SSD-8586218 – TEMPERATURE CONTROLLED WAREHOUSE FACILITY SECTION 4.55(1A) MODIFICATION APPLICATION

This application has been prepared by Ethos Urban on behalf of ESR Developments (Australia) Pty Ltd, pursuant to Section 4.55(1A) of the *Environmental Planning and Assessment Act 1979* (EP&A Act) to modify Development Consent SSD-8586218 relating to a temperature-controlled warehouse facility within the Bringelly Road Business Hub at Lot 4, Skyline Crescent (the site).

Figure 1 Indicative Plan for Large Flush Wall Sign

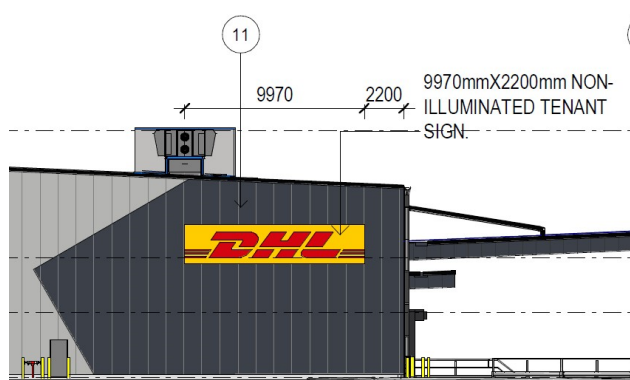
This modification seeks approval of business identification and directional signage at the site. Specifically, approval is sought for the installation of five (5) flush wall signs and six (6) free-standing pylon signs.

The flush wall signage will include the logo and branding of the tenant operating at the site being DHL. Five pylon signs will include the logo and name of the estate operator ESR. One pylon sign will display DHL branding as well as the site address.

Figure 4 Level 1 Floor Plan

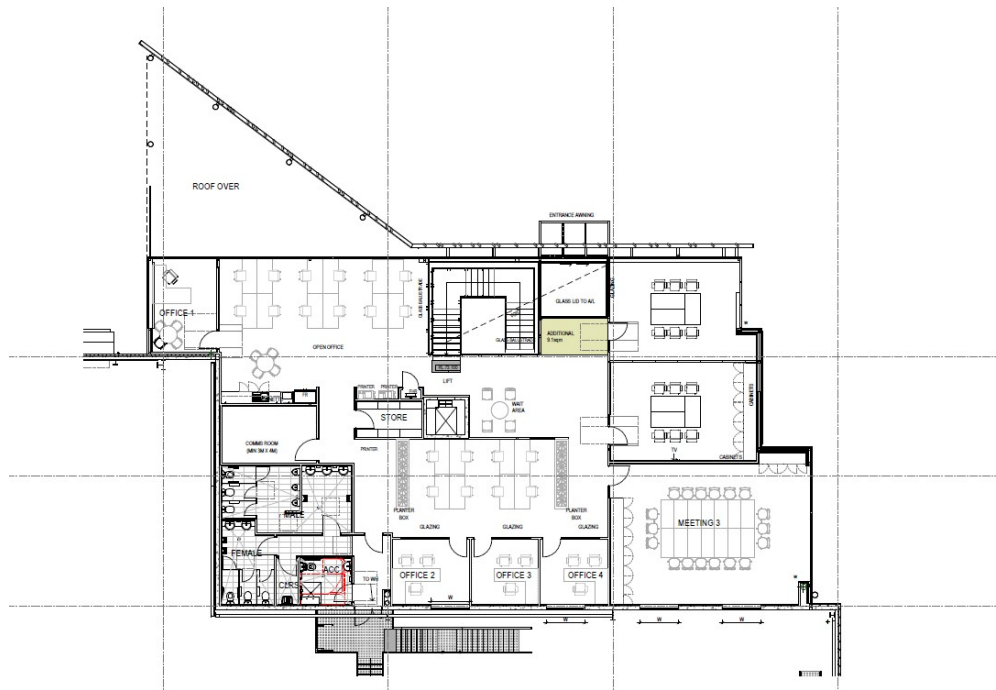
The modification seeks approval for an additional 9.1m² of floor area on Level 1 of the office (refer **Figure 4** below). The additional GFA is needed to facilitate amended access to meeting rooms.

Figure 6 Proposed modifications to the Outdoor Forecourt Area

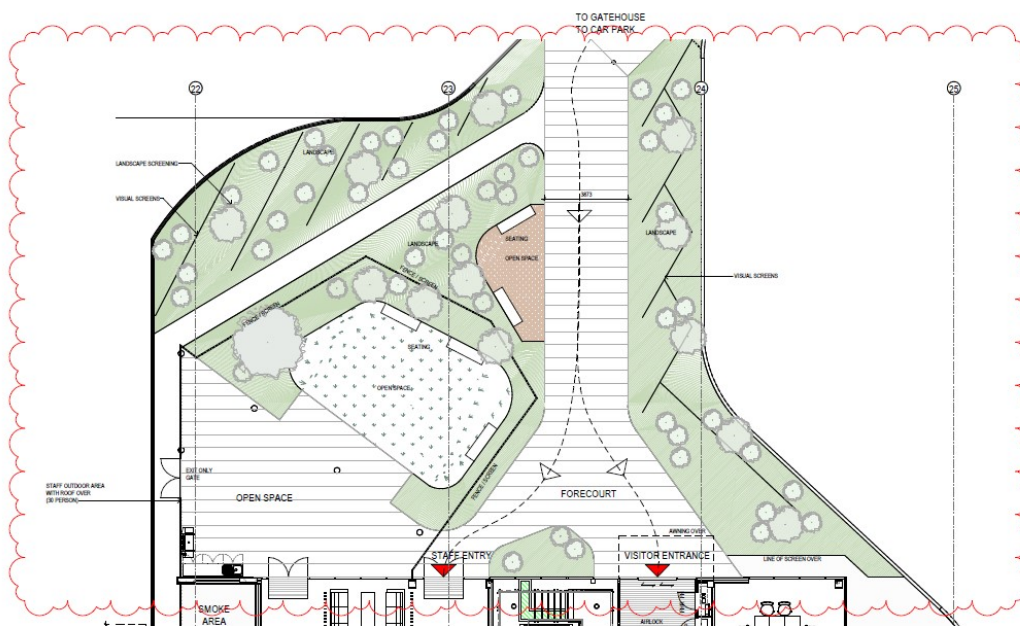
The proposed modifications include improvements to the forecourt area and specifically results in an increase in the landscaped open space. The modification proposes two (2) additional mature canopy trees within the forecourt area. The modification will enhance the amenity on site for both visitors and staff. Refer to landscape plans at **Attachment B** for further details.

Figure 5 provides an excerpt of the stamped outdoor staff area in comparison to **Figure 6** which provides the proposed modifications to the area.
